Rate of Return Instrument Review

Response to AER's Draft Instrument and
Explanatory Statement

2 September 2022

Figure 1: Comparison between 10-year and 5-year allowed return on equity

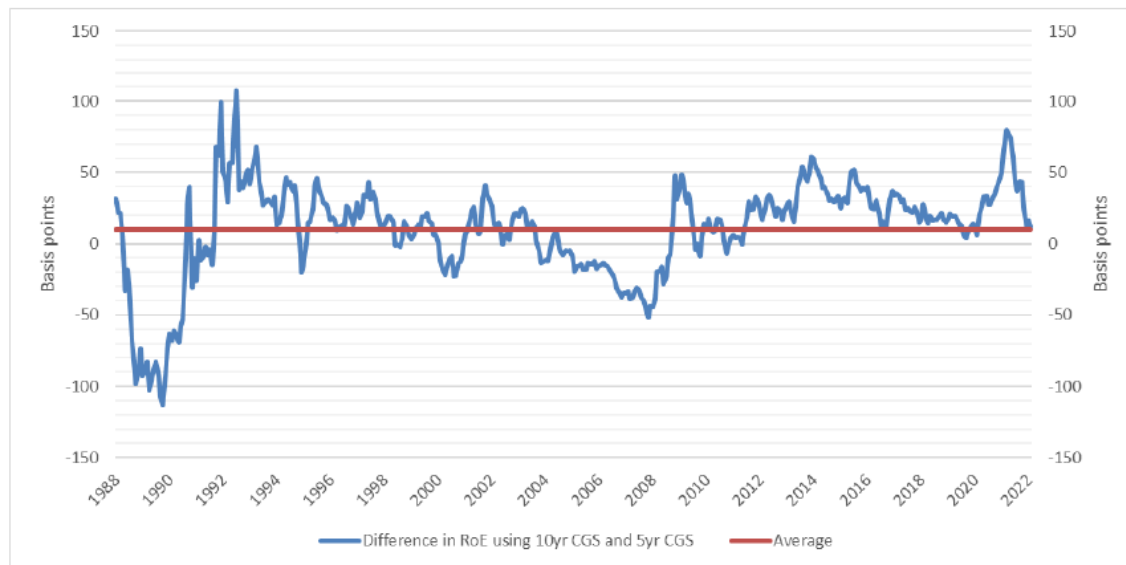
ENA also notes that one of the important implications of the proposed change is that consumers will be asked to pay *more* than under the current approach during recessions and financial crises. The *Explanatory Statement* shows two pronounced periods – the major recession in the early 1990s and the peak of the GFC – where yield curves inverted such that the proposed new approach would increase consumer prices relative to the current approach. See Figure 1 below, reproduced from the *Explanatory Statement*.

ENA questions whether now is the right time to be applying a further reduction to an allowed return on equity that is already below commercial and regulatory benchmarks – given the tremendous amount of network investment that is required over the next decade.

Figure 2: Margin between 25-year re-setting bond and 5-year government bond

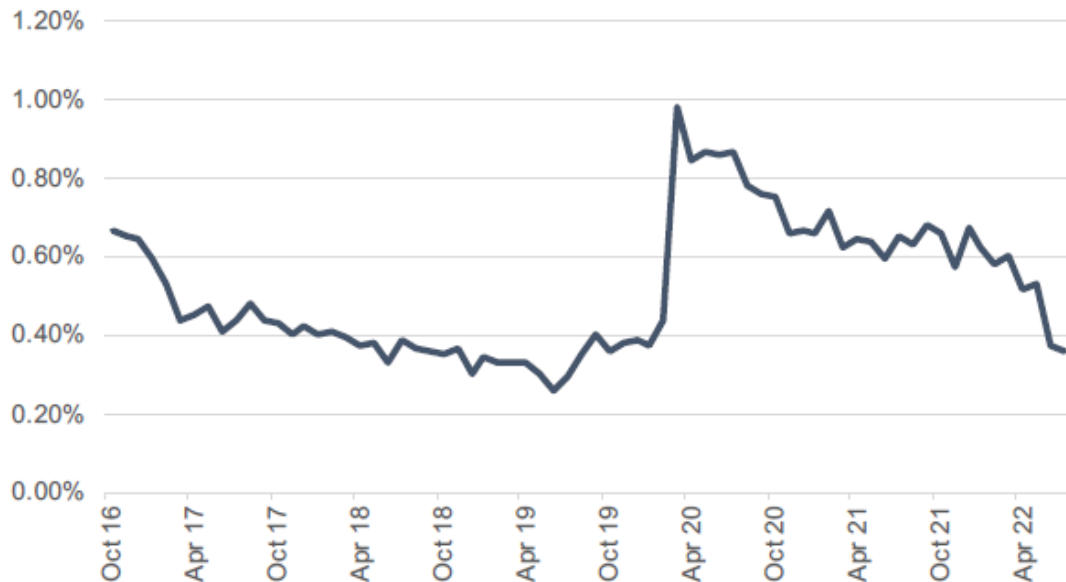
The QTC submission demonstrates how this differential can be quantified. QTC estimates the yield on a synthetic long-term bond where the coupon re-sets to the prevailing 5-year government bond yield every 5 years. The results are summarised in Figure 2 below.

Figure 2 shows, and QTC reports, that the margin that must be paid on the long-term re-setting bond, relative to a standard 5-year bond, averages 51 basis points. Over the same period, the average differential between the 10-year and 5-year government bond yield is 44 basis points.¹¹²

Figure 3: AER vs. calibrated DGM estimates of MRP

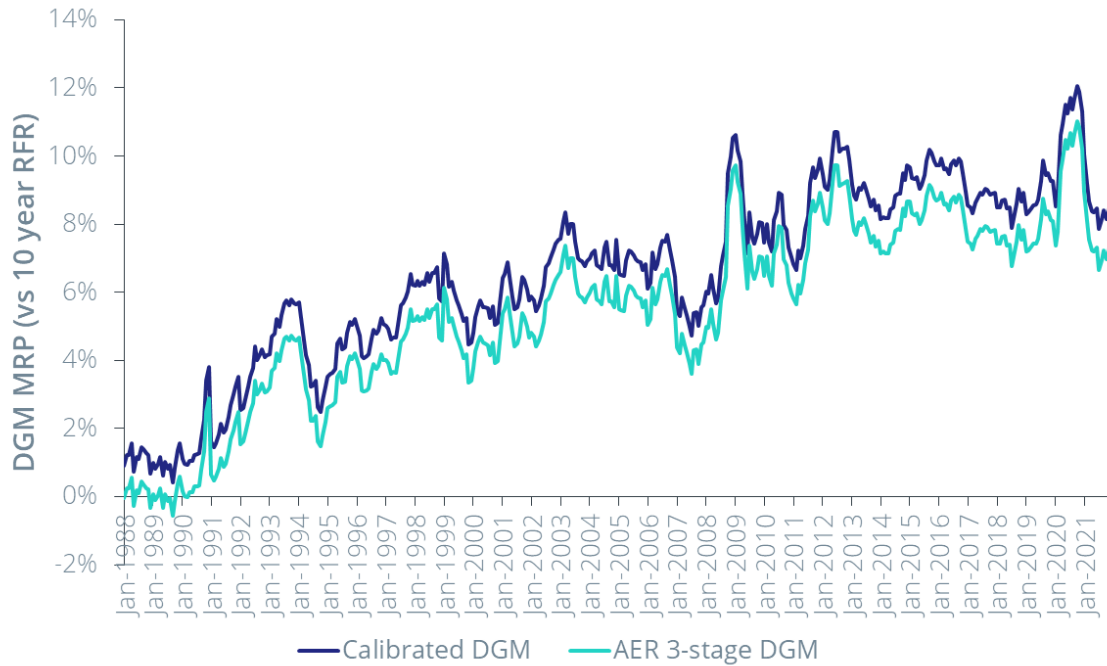
In relation to the volatility of estimates over the 1988-2021 period, we make two observations. The first is that the AER's preferred specification of the DGM generates estimates that are equally volatile. Figure 3 below plots the AER DGM estimates of the MRP alongside the calibrated DGM estimates. That figure shows that:

Figure 4: DGM vs. HER approaches to the allowed return on equity

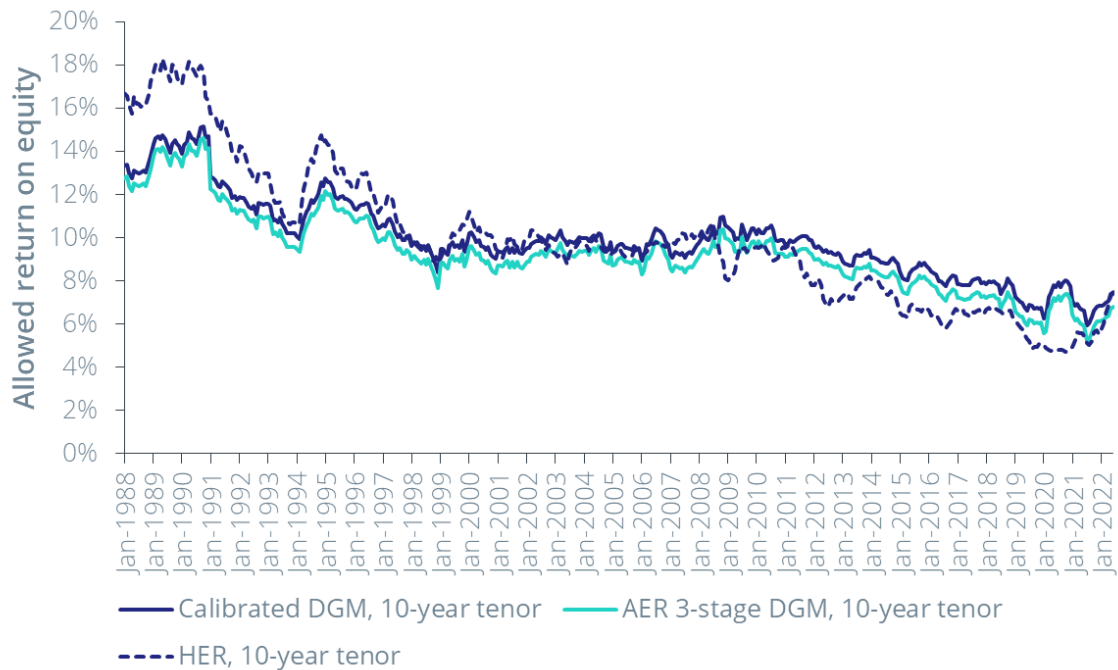
Relative to the DGM estimates, the HER approach produces materially higher allowed returns during periods of high interest rates and materially lower allowed returns during periods of low interest rates. The greater stability in the DGM estimates results in the implied MRP changing in a way that absorbs/offsets some of the volatility in risk-free rates.

Figure 5: Excess and real returns: 1988-2021

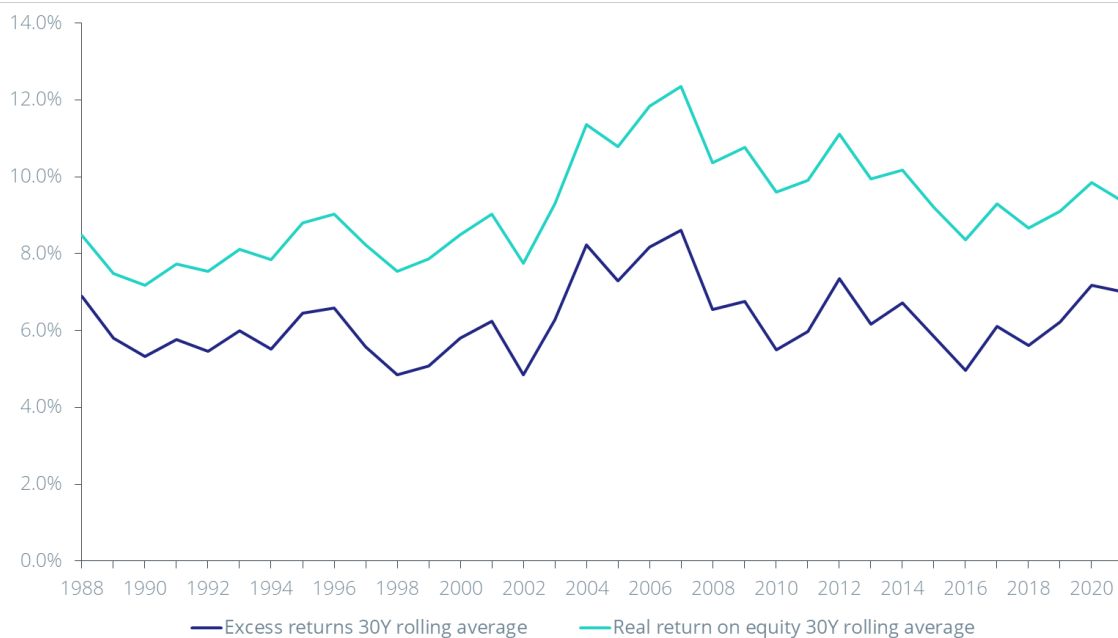
Finally, given that the AER proposes to apply primary weight to the historical period from 1988-2021, that is the relevant period for any tests of stability. The excess returns and real returns series – for the period that forms the basis of the AER’s allowance – are displayed in Figure 5 below.

Figure 5 shows that the pattern of excess returns and real returns is almost indistinguishable over the relevant period. It certainly does not support the conclusion that one approach should receive 100% weight and the other 0% weight on the basis of their relative stability.

Figure 6: International equity beta estimates and AER proposed beta

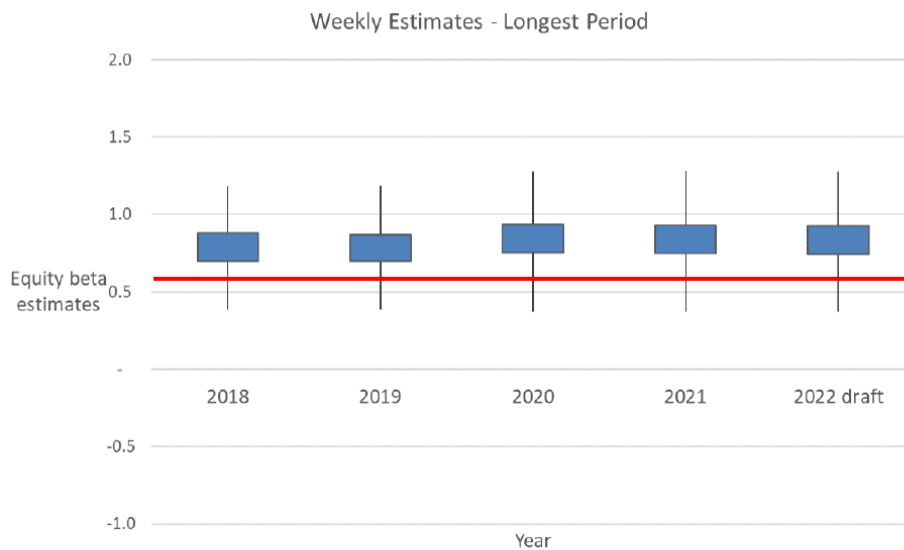
The AER reports equity beta estimates for a set of international comparator firms, as set out in Figure 6 below. That figure shows that the current international evidence supports an equity beta very materially higher than the AER's proposed allowance of 0.6 (marked in red on the figure).

Figure 7: Returns on high-beta and low-beta stocks

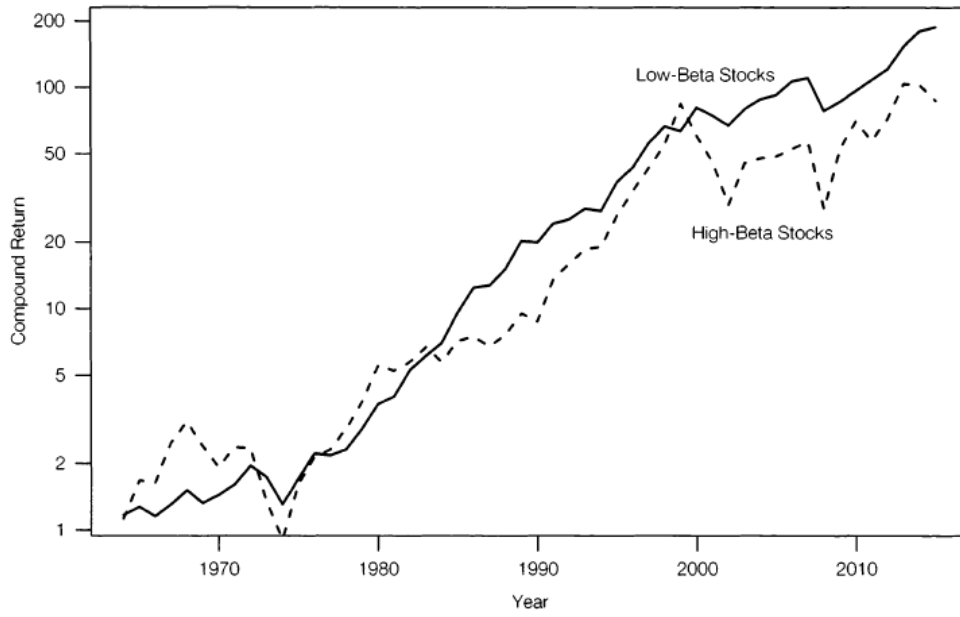
By way of example, Levi and Welch (2017) have noted that low-beta stocks have outperformed even high-beta stocks over the last 50 years, as summarised in Figure 7 below.

Figure 8: Comparison of allowed returns under 2018 RoRI and draft 2022 RoRI

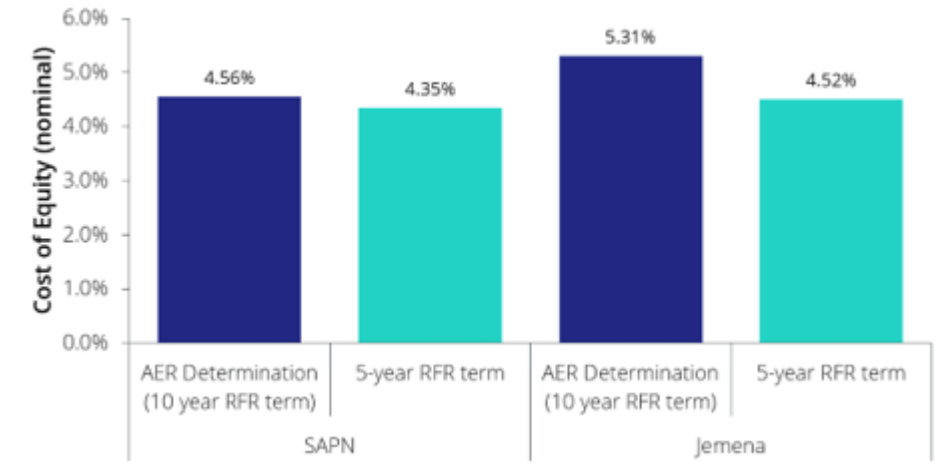
Remarkably, the proposed changes in the draft 2022 RoRI would result in *even lower* regulatory allowances in that same low-rates scenario. For example, Figure 8 below shows that the allowed return on equity for the 2020 SAPN and Jemena decisions would have been even lower under the approach proposed in the draft 2022 RoRI.

Figure 9: Comparison of allowed returns under 2018 RoRI and draft 2022 RoRI

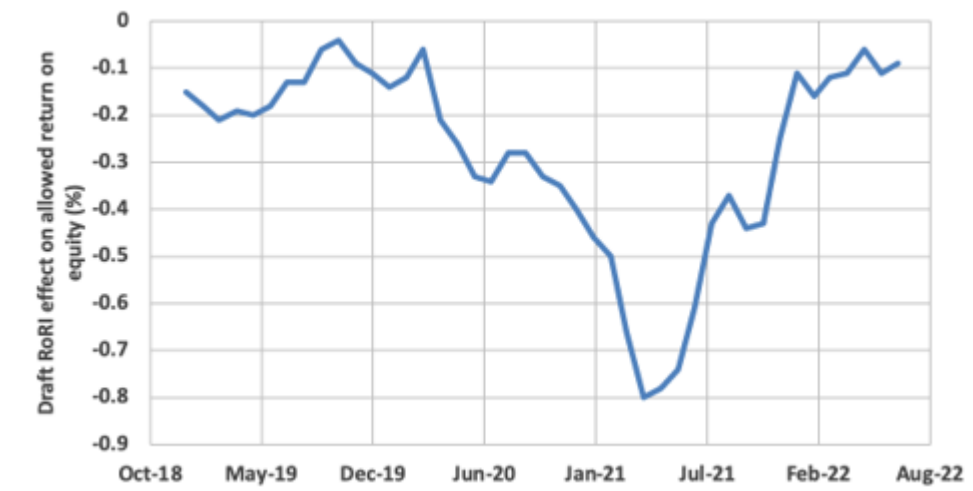
Figure 8 below shows that the allowed return on equity under the draft 2022 RoRI would have been up to 80 basis points lower than the corresponding allowance under the 2018 RoRI.
